RULE NO.: R161-21.28
POSTING DATE: October 6, 2021

NOTICE OF PROPOSED RULE

R161-21.28: Modifies the Standards Manual to align with the Environmental Criteria Manual 1.6.4(A) as follows:

Standards Manual: SERIES 500 - PIPE AND APPURTENANCES.

BIOFILTRATION BED CONFIGURATIONS USING GEOMEMBRANE/CLAY LINER

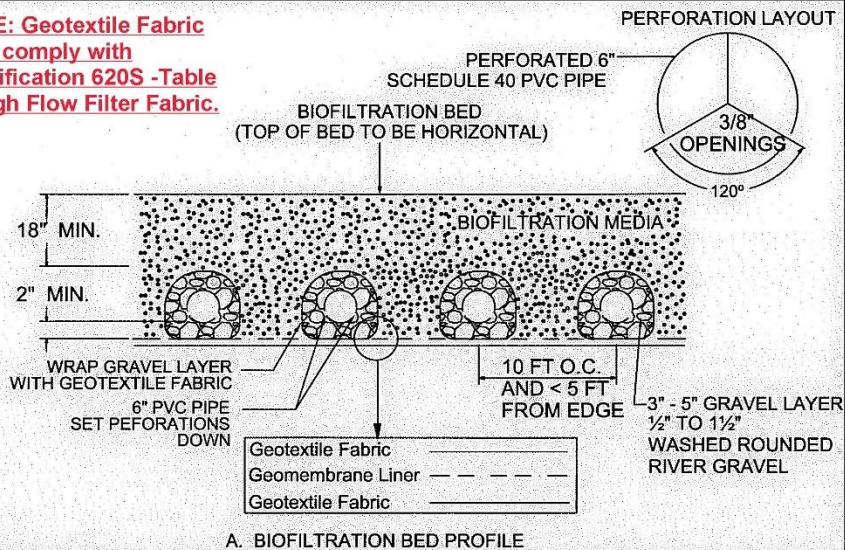
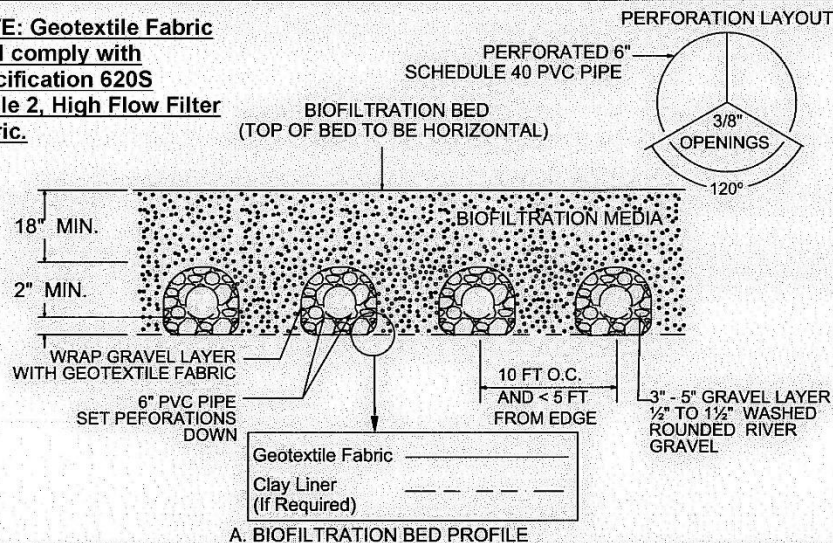
- Standard No. 661-1 - Changes fabric specification to match geotextile fabric requirement in ECM 1.6.5(A)(4) ("High Flow Filter Fabric").
- Standard No. 661-2 - Changes fabric specification to match geotextile fabric requirement in ECM 1.6.5(A)(4) ("High Flow Filter Fabric").
- Standard No. 661-3 - Changes fabric specification to match geotextile fabric requirement in ECM 1.6.5(A)(4) ("High Flow Filter Fabric").

NOTE: Geotextile Fabric shall comply with Specification 620S - Table 2, High Flow Filter Fabric.

NOTE: Geotextile Fabric shall comply with Specification 620S - Table 2, High Flow Filter Fabric.
